Architect's Supplemental Instructions

Wilma P. Mankiller Health Center
Expansion
Stilwell, OK

ASI Number: Bid Package 02 ASI 006

Construction Documents – ASI 06 – Wilma P. Mankiller Health Center Expansion

ROOF DETAILS

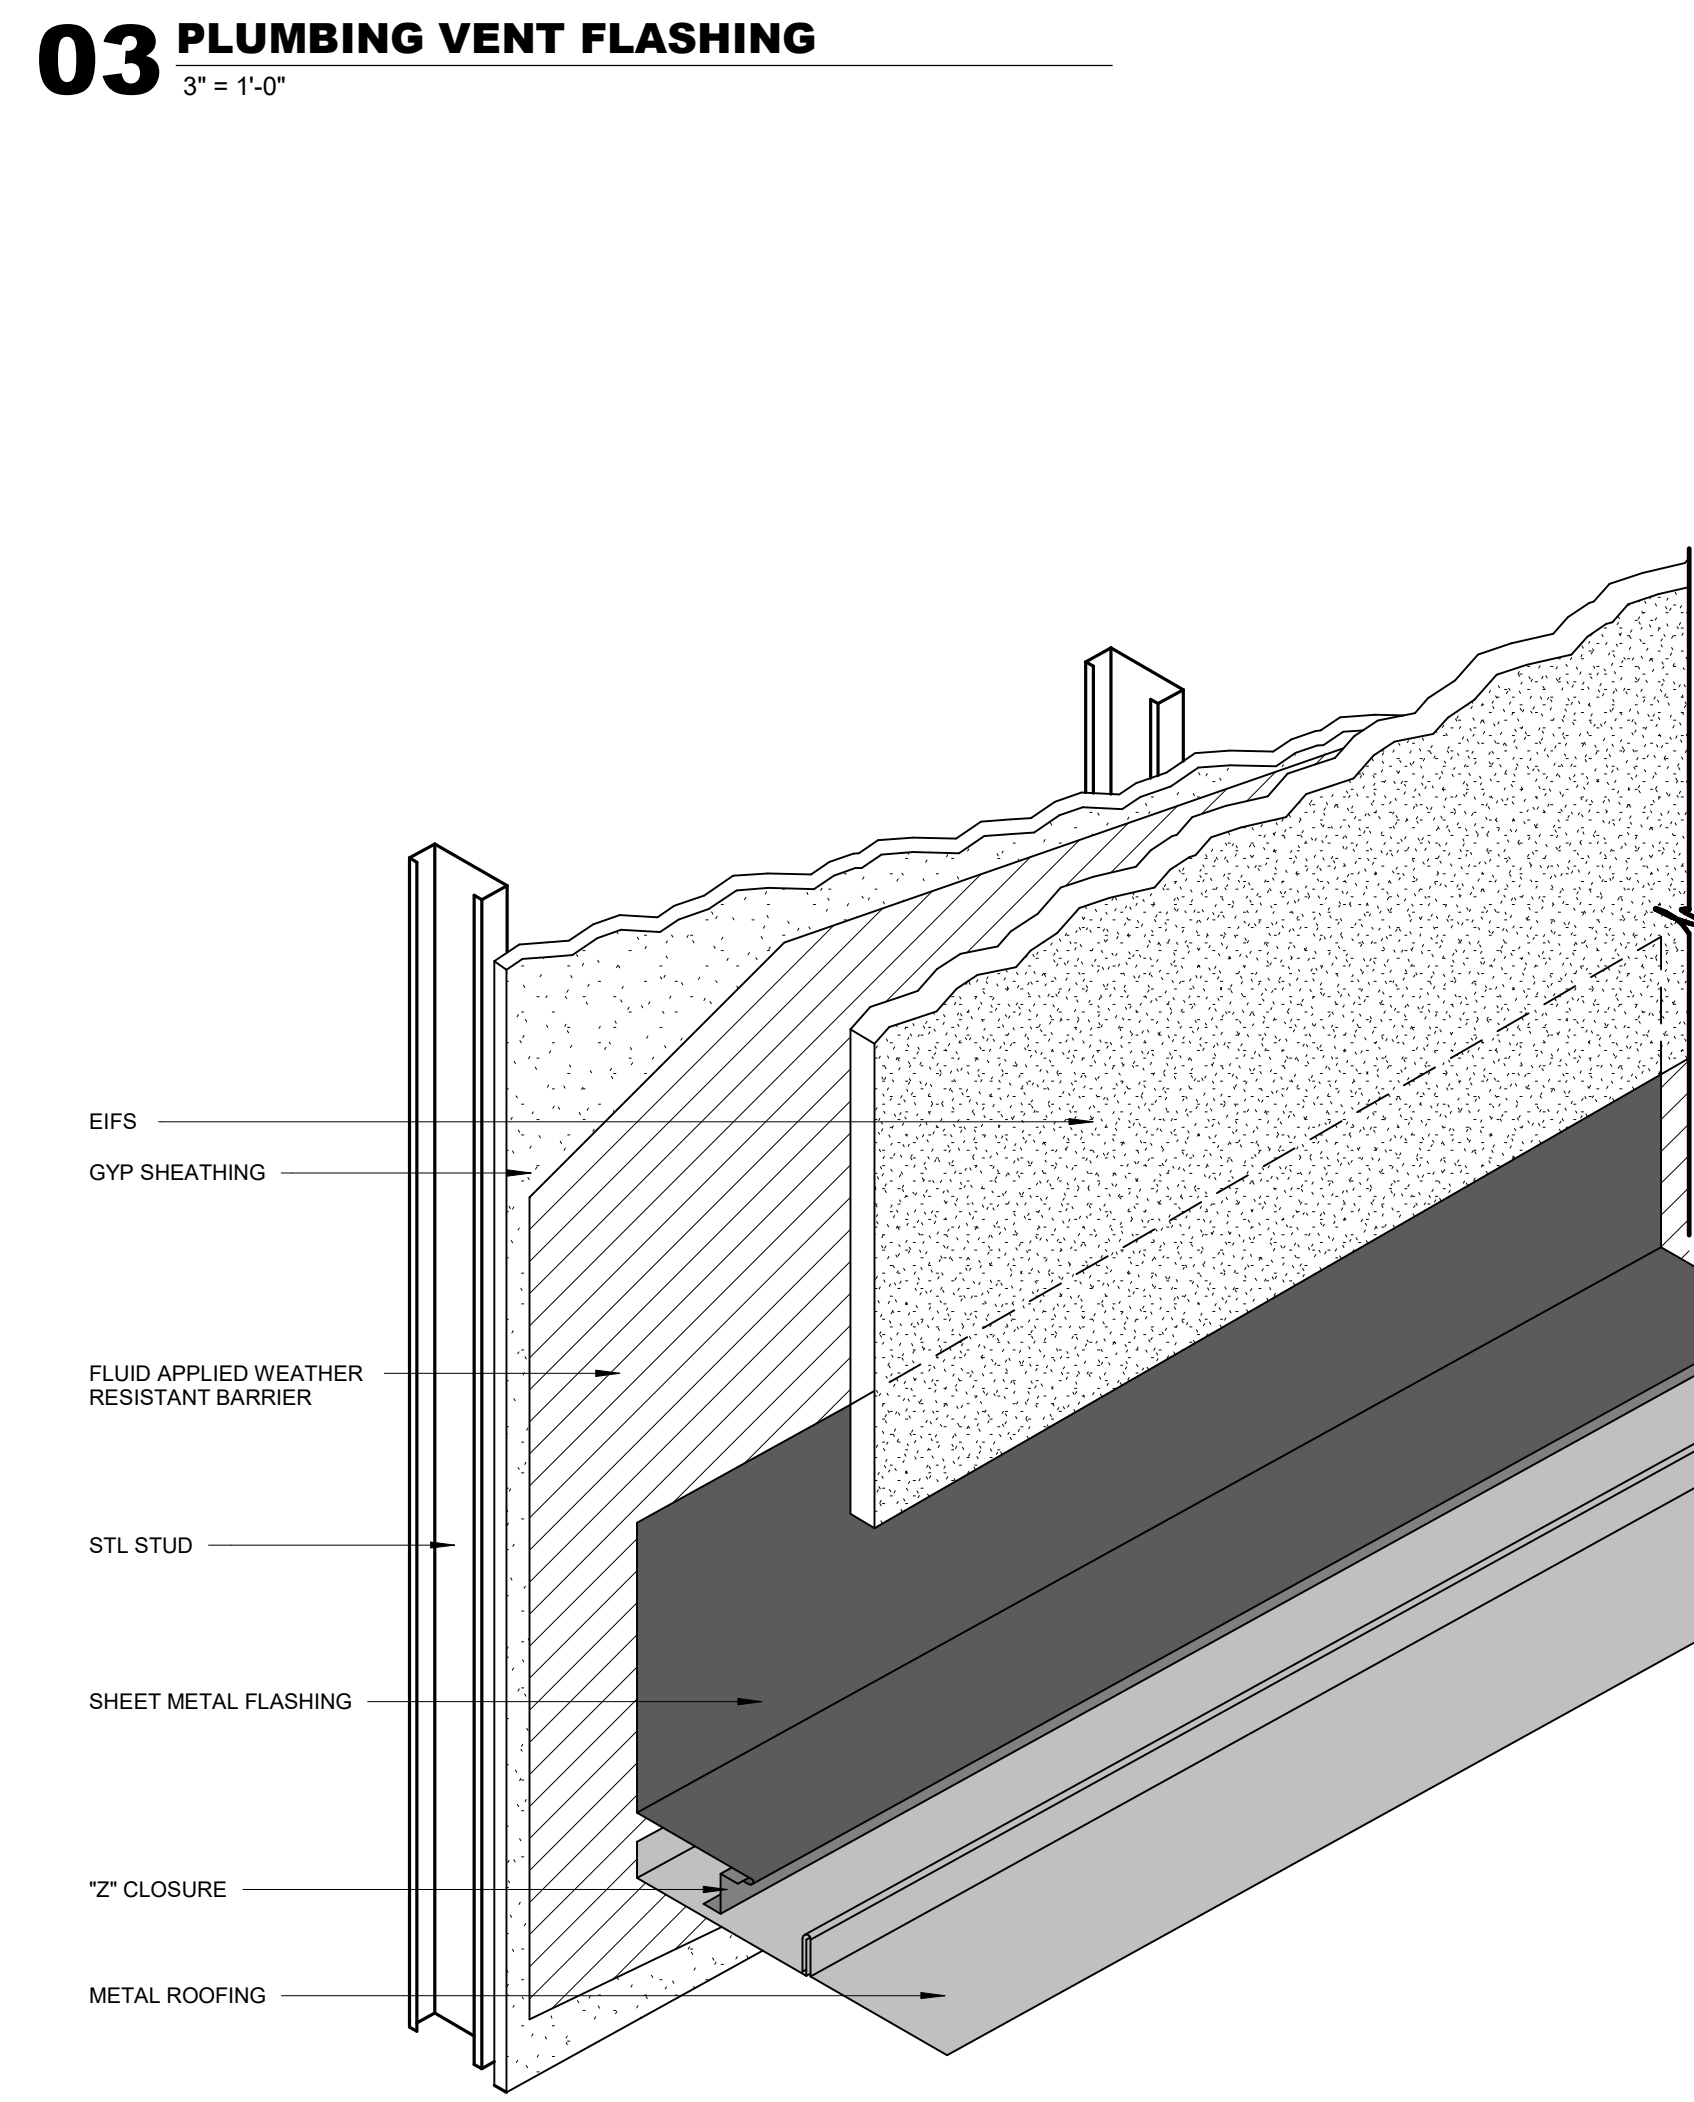
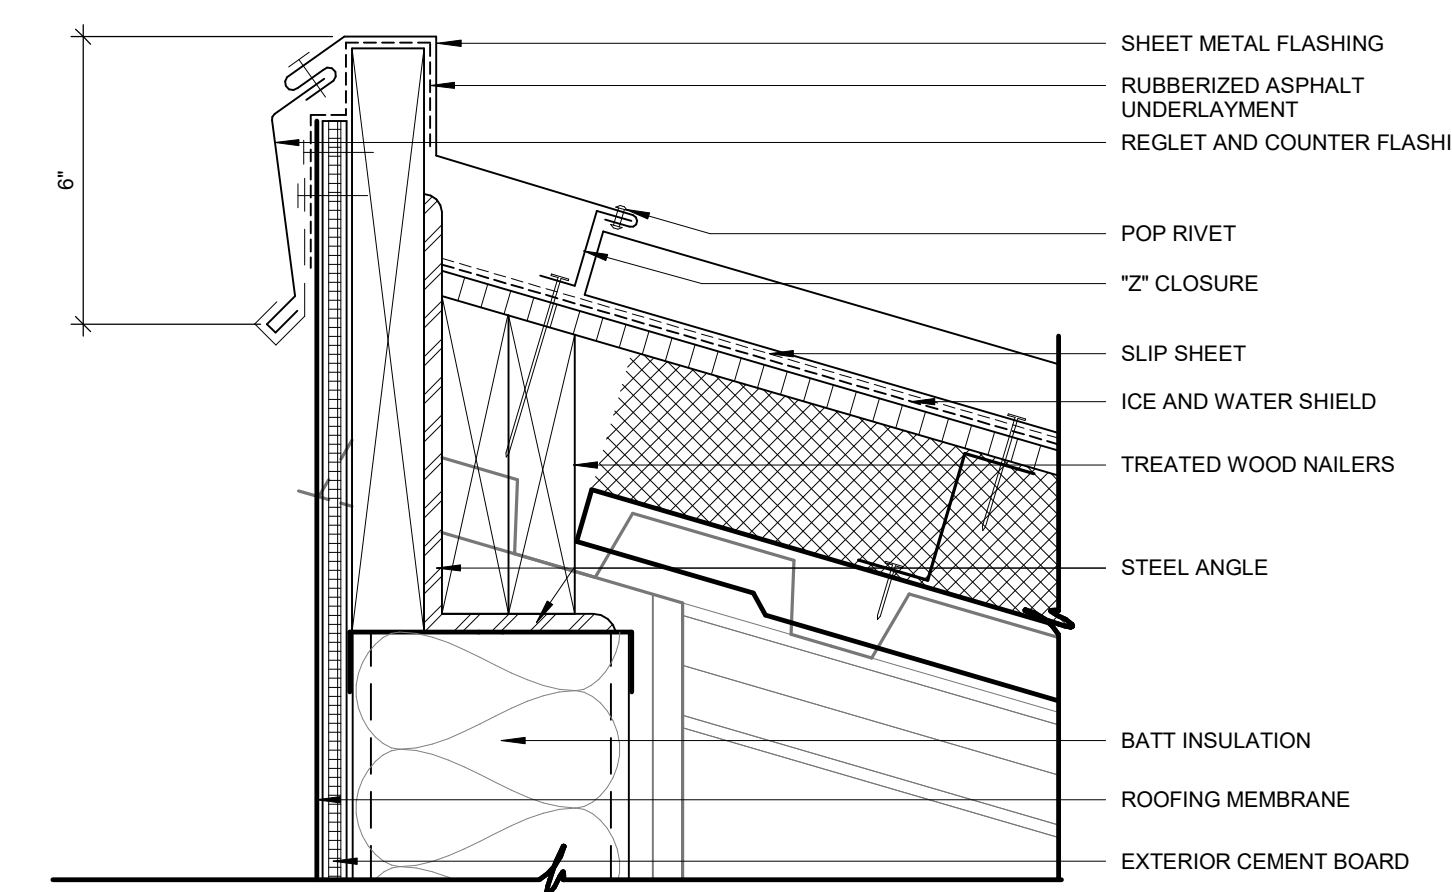
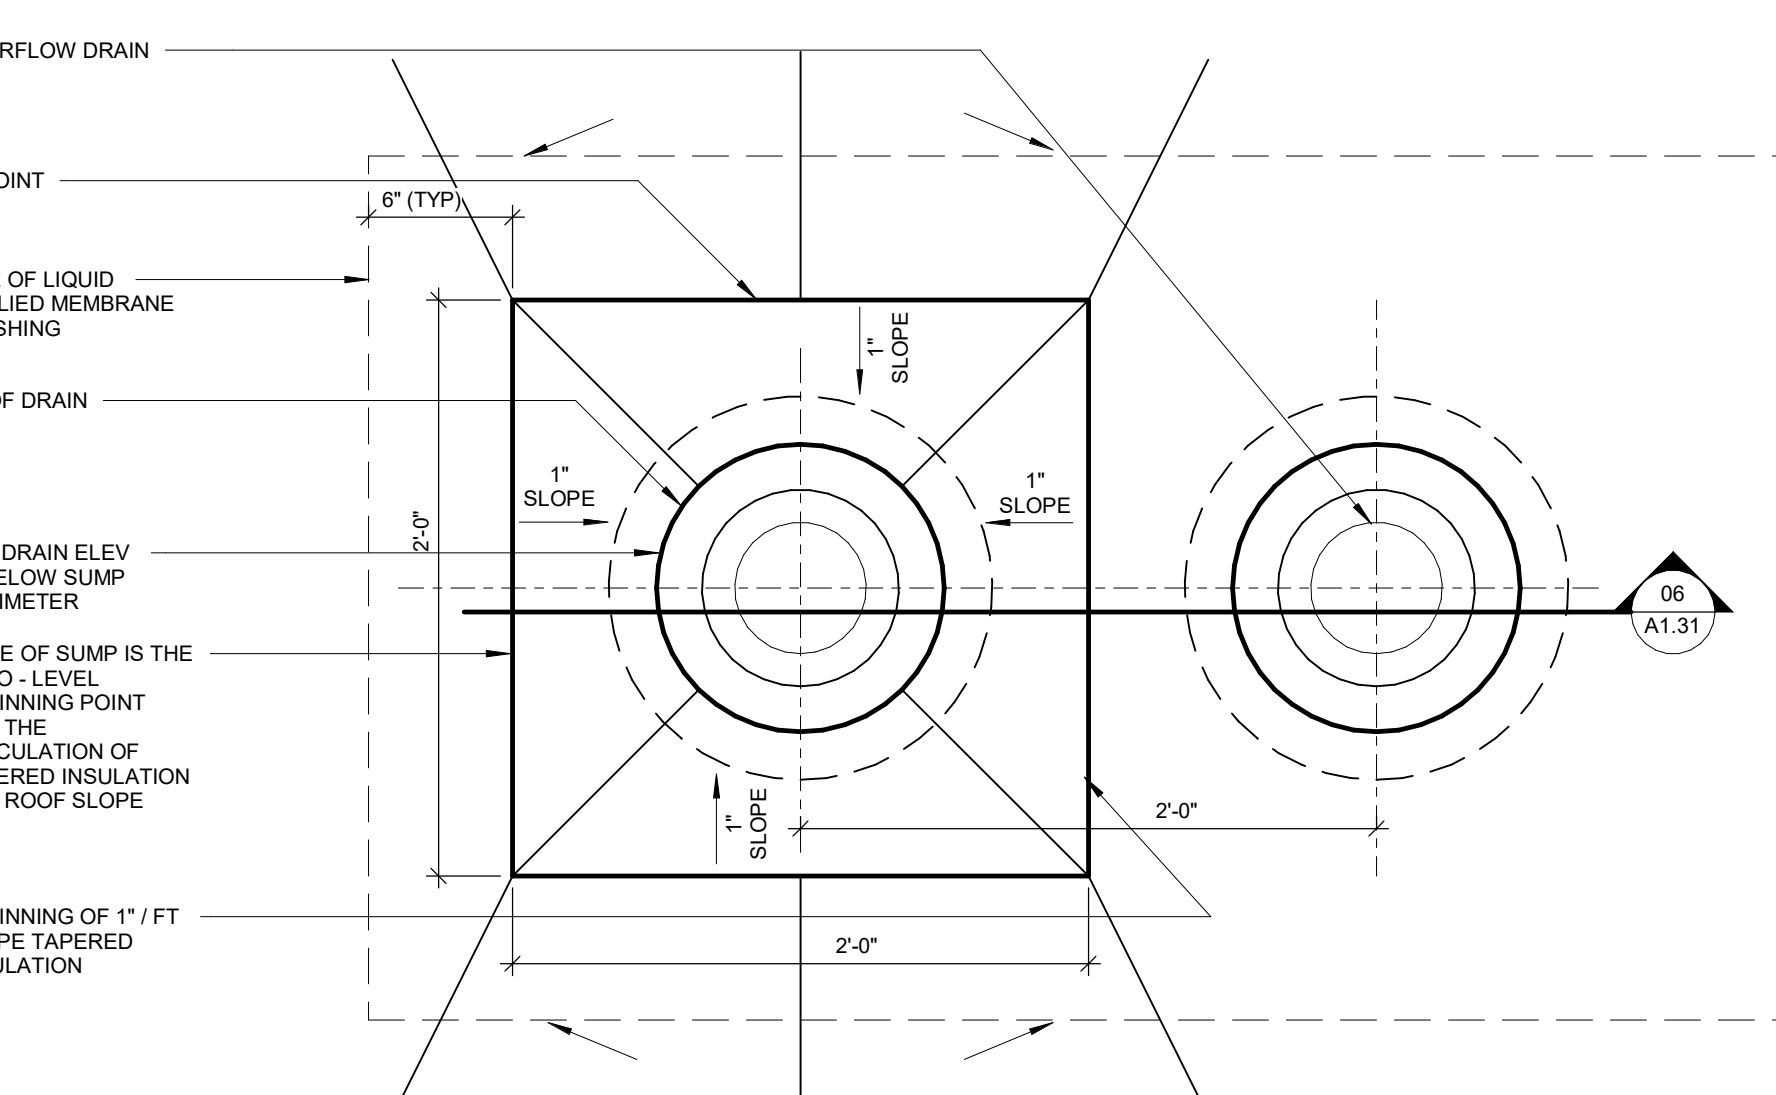
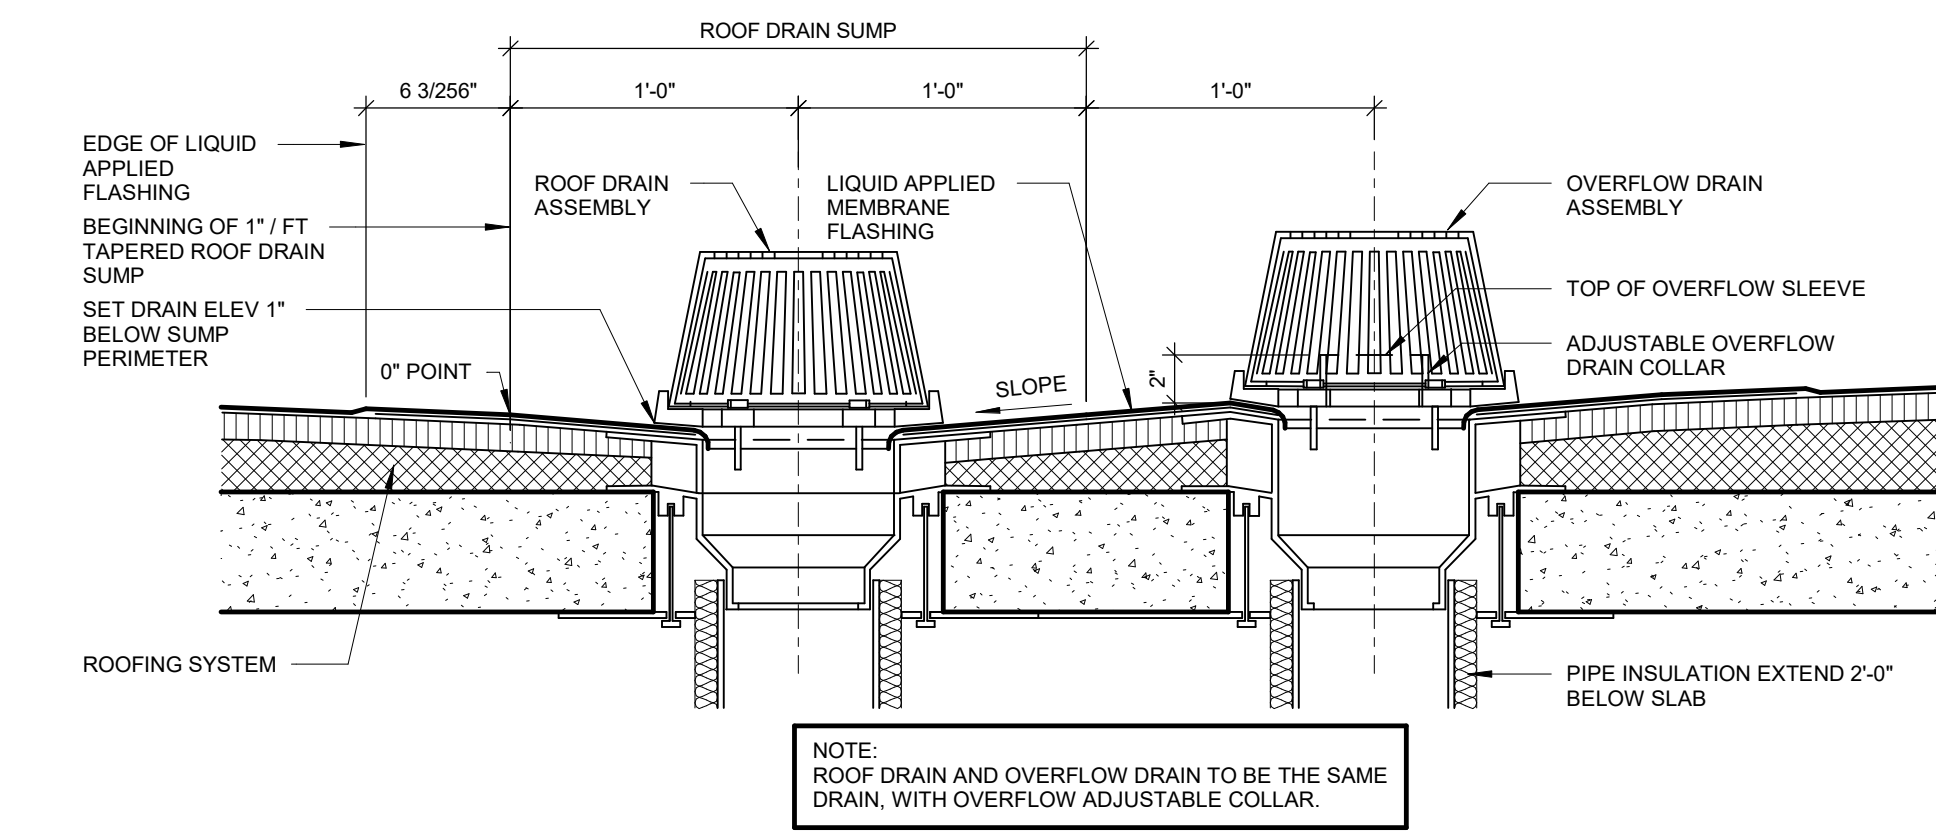
A5.10

1. Canopy Edge Detail added
